Bulletin No: N031714
Release Date: March 17, 2014
Effective Date: Immediate
Supercedes: N/A
Completion Date: Immediate
Page: 1 of 1

SERVICE BULLETIN

Manufacturer: A.R.M. (USA), Inc.
Ride Name: Fixed-Site Super Shot

Model(s): 1002 & 1003
Production Dates: Prior To March, 2014

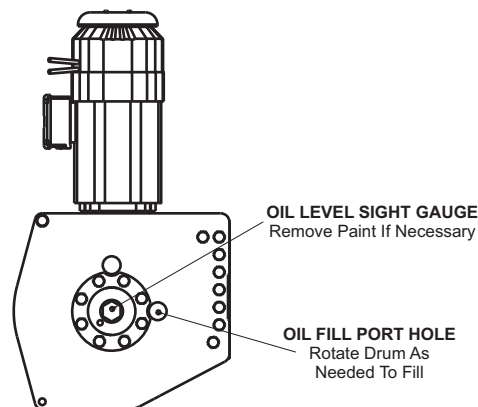
Immediate inspection of oil level in the auxiliary hoist unit rope drum and addition of oil if required.

A.R.M. (USA), Inc. has become aware that certain auxiliary hoist units were supplied from the manufacturer without adequate amount of oil in the drum. Additionally, some units were supplied with the oil level inspection glass covered with paint.

If the oil level inspection glass has been painted, it must first be cleaned for inspection. The oil reservoir must then be inspected and filled to appropriate level according to the manufacturer manual. Total oil capacity is approximately 7 pints. Manufacturer recommended oil is Mobilgear SHC 629 or 630 synthetic gear oil or equivalent

1. Remove paint or debris from oil level sight gauge.
2. Rotate drum so fill port aligns with the indicated hole in the frame.
3. Check/fill oil level as specified in the Auxiliary Hoist Owner's Manual.
